Memorandum

To: Planning and Zoning Commission
From: Elizabeth Maxwell
Date: May 18, 2011
Re: 2010-69 Schafer Subdivision

#2010-69
Schafer Subdivision
Project Review for the Planning and Zoning Commission

<u>Meeting Dates:</u>	May 4, 2011
<u>Zoning Request:</u>	Final PUD / Final Plat of Subdivision for five single-family lots.
<u>Location:</u>	1351 W. Route 176, west of Lippold Park
<u>Acreage:</u>	Approximately 7.92 acres
<u>Existing Zoning:</u>	W PUD Watershed district
<u>Surrounding Properties:</u>	North: W Watershed, Sunset Meadows Park South: County R-1 Residential district, Single-family houses East: W Watershed, Lippold Park West: W PUD Watershed, CLPD Daycare facility
<u>Staff Contact:</u>	Elizabeth Maxwell (815.356.3615)

TREE PRESERVATION PLAN SCHAFFER'S SUBDIVISION

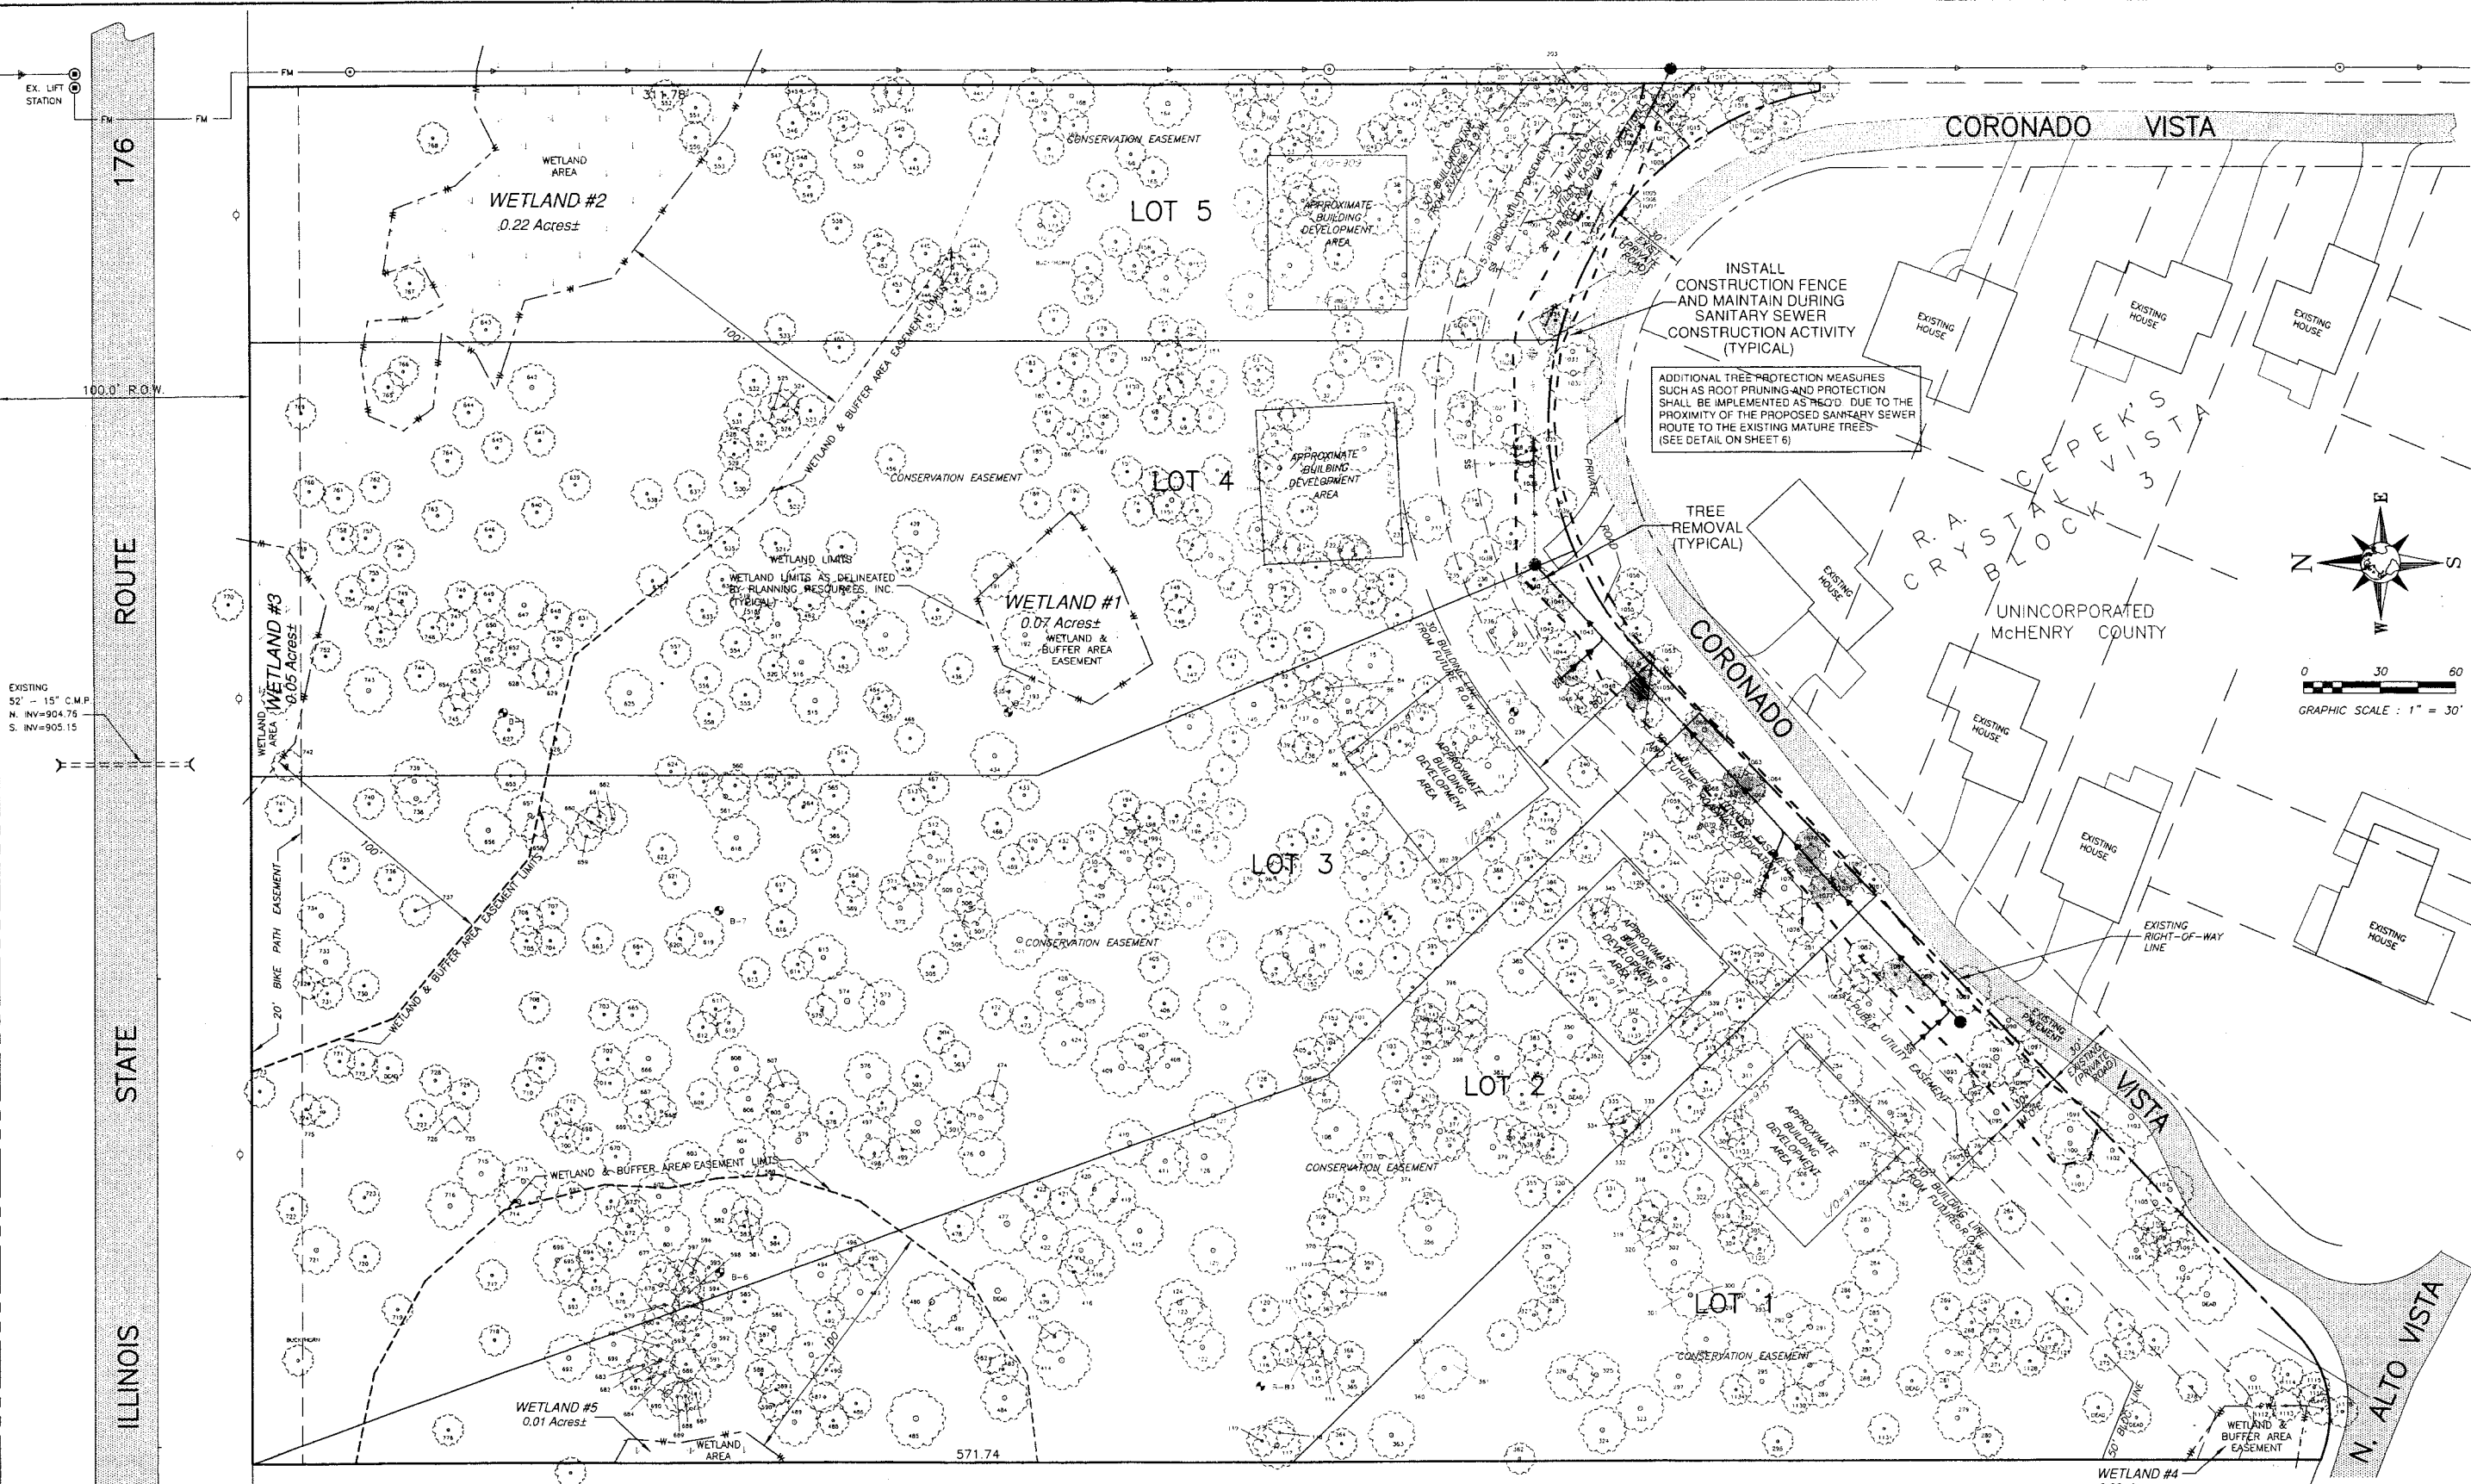
- B. Clarification is needed on the tree removal for trees #1076 and #1100. Tree #1100 should not be removed and the limits of disturbance for the sanitary sewer line shall be adjusted. Tree #1076 may be labeled incorrectly or twice.
